Re: Unorthodox Location  
 David Fasken  
 Mobil "10" Federal No. 1  
 Indian Basin (Morrow) Field  
 Sec. 10, T-21-S, R-24-E,  
 NMPM, Eddy Co., New Mexico

APPLICATION FOR PERMIT TO DRILL, DEEPEN, OR PLUG BACK

MEXICO OIL CONSERVATION COMMISSION  
WELL LOCATION AND ACREAGE DEDICATION PLAT

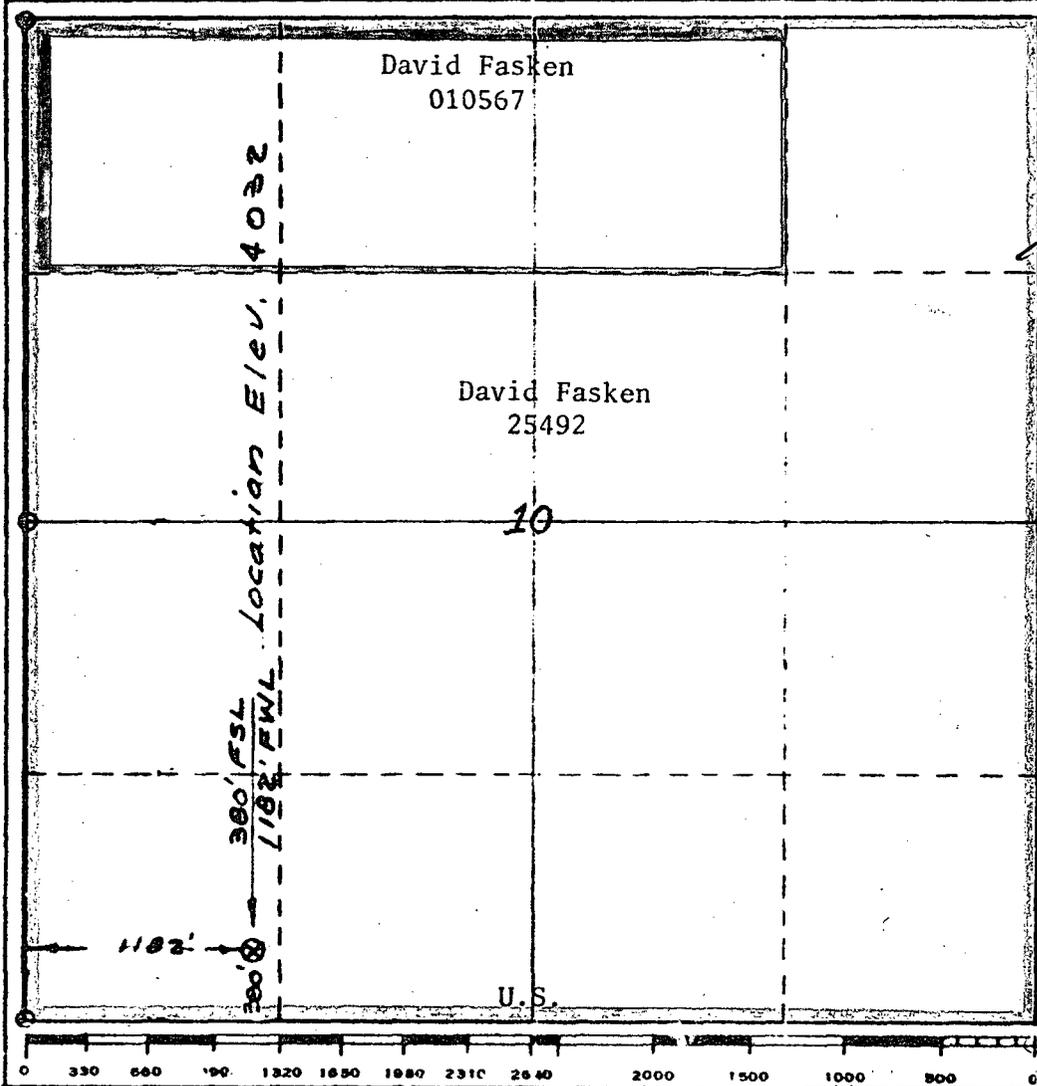
Due to the extreme topography and configuration of the surface in  
this mountain area, this is the best place to drill above said  
location. After consulting with Mr. Robert Angenvine with Fasken,  
the USGS, BLM and the Dirt and drilling contractor we all agree.
